**REPORT OF THE CITY OF CORAL GABLES
HISTORICAL RESOURCES & CULTURAL ARTS DEPARTMENT
TO THE HISTORIC PRESERVATION BOARD
ON THE DESIGNATION OF
THE PROPERTY AT
3701 DURANGO STREET
CORAL GABLES, FLORIDA
AS A LOCAL HISTORIC LANDMARK AND
SPECIAL CERTIFICATE OF APPROPRIATENESS
FOR ALTERATIONS AND ADDITIONS TO THE PROPERTY**

**LOCAL HISTORIC DESIGNATION and
SPECIAL CERTIFICATE OF APPROPRIATENESS FOR ALTERATIONS
to the property at
3701 DURANGO STREET
CORAL GABLES, FLORIDA**

LOCAL HISTORIC DESIGNATION REPORT – LHD 2018-005

**SPECIAL CERTIFICATE OF APPROPRIATENESS REPORT
COA (SP) 2018-005**

Figure 2: Lots 1-3, Block 43, Coral Gables Country Club Section 3

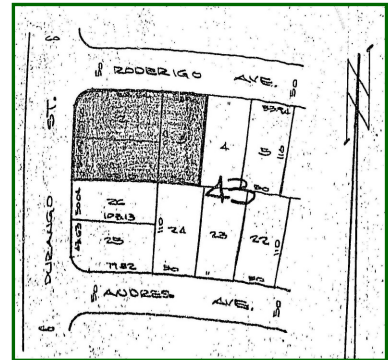
This property is comprised of three lots. Lots 1 and 2 run east-west and lot 3 runs north-south. The narrow end of a lot is considered to be its front. Hence, this property is considered to have two frontages, one along Durango Street corresponding to Lots 1 and 2 and the other along Roderigo Avenue corresponding to Lot 3. Therefore, the property technically has two rears. The standard minimum rear setback of 10' along the south and east property lines is required. The applicant is requesting an 8'-6" setback along the south property line. Since the setback along the south property line would be 5' if it were to be considered a side of the property Staff supports this variance request.
